RECALL BULLETIN:
101105FRV

Terra, built 6/24/2010 through 10/4/2010

MODEL(S) AFFECTED:
31TS, 34DS

SUBJECT:
Inspection/Correction of high-beam and low-beam headlights

Figure 1 - INCORRECT Headlights

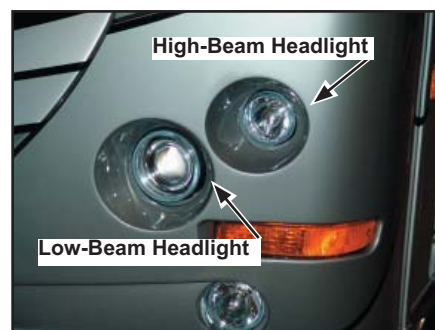
The 2011 Terra motor homes affected by this recall were built with the high-beam and low-beam headlights in the incorrect locations, as specified by the standards of FMVSS108.

According to the pertinent language of FMVSS108, the lower beam should be provided by the “outboard light source (or the uppermost if arranged vertically)”, and the upper beam should be provided by “the inboard light source (or the lower one if arranged vertically)”. An example of incorrect headlights is shown in Figure 1 and an example of correct headlights is shown in Figure 2.

1. Park the motor home and examine the headlights. The low-beam headlight should be located in the higher, outboard position (as shown in Figure 2). The high-beam headlight should be located in the lower position, nearer the center of the cap. An example of a low-beam headlight is shown in Figure 3, and an example of a high-beam headlight is shown in Figure 4.

If the headlights are not located in the positions described above, proceed to the CORRECTION, Step 2.

Figure 6 - Headlights and bracket assembled inside of front cap

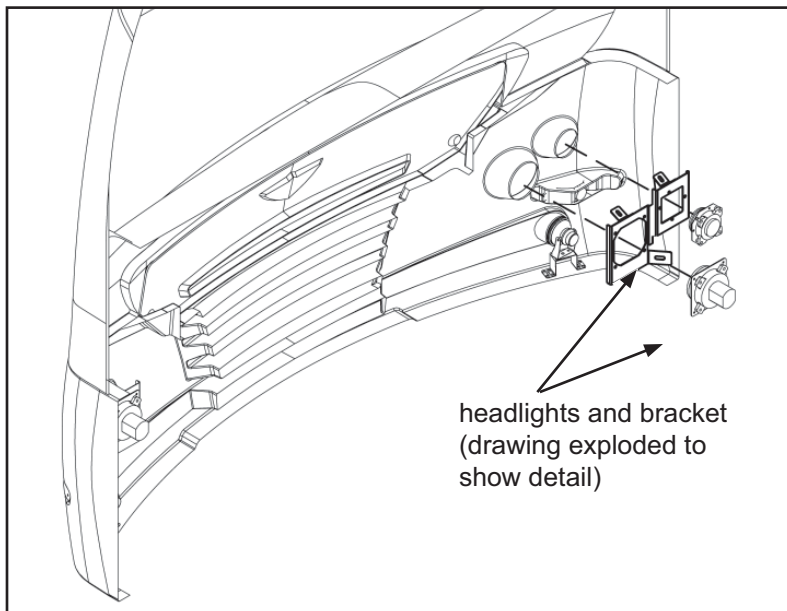
6. Remove the fasteners for the headlights from one of the brackets, noting stacking order of the hardware. Retain the original fasteners and mounting bracket for assembly of the new headlights. Discard the original high-beam and low-beam headlights.

7. Fasten a new high-beam and low-beam headlight, included with the Recall Kit, into the original mounting bracket, using the hardware retained in Step 6. Torque nuts to 50-55 inch-lbs.

8. Plug the headlight wire harnesses (included with each new headlight) into the back of the new lights.
9. Position the headlight assembly inside the lower front cap and reinstall the bracket onto the studs in the cap using original fastening hardware. Torque nuts to 40-45 inch-lbs.
